# Access Compliance Report

## Public Rights-of-Way

| Intersection ID: 24279                  | Main Street: EDENBRIDGE_LN | Cross Street: WINDYRUSH_RD              | Location: S            |
| ADA ID: D5F3EA071AA0                    | Ramp Type: PerpDiag        | Initial Pass/Fail: Fail                 | Overall Compliance: No |

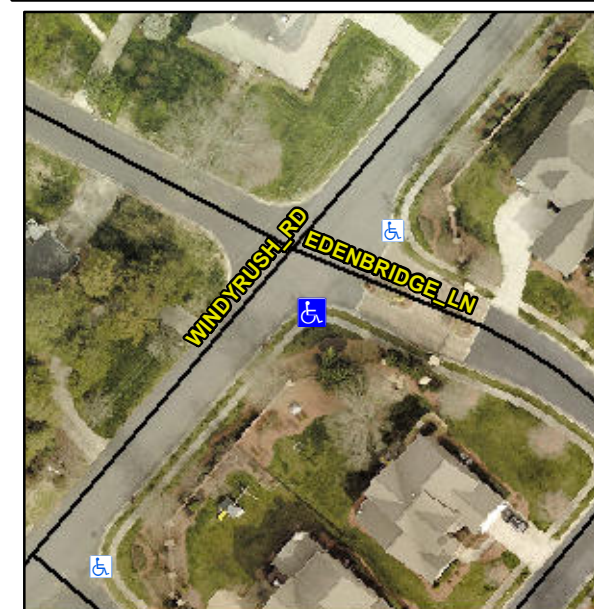
**Not Found, R304.5.1, R304.2.2, R304.5.3**

| Compliance | Description           | Data  | Compliance | Description                 | Data  |
|------------|-----------------------|-------|------------|-----------------------------|-------|
| N/A        | Ramp Length (in)      | 44.0  | No         | Ramp Slope (%)              | 9.9   |
| No         | Ramp Width (in)       | 42.0  | No         | Ramp XSlope (%)             | 4.9   |

**Remove & Replace Curb Ramp With Two New Directional Ramps or Equivalent.**
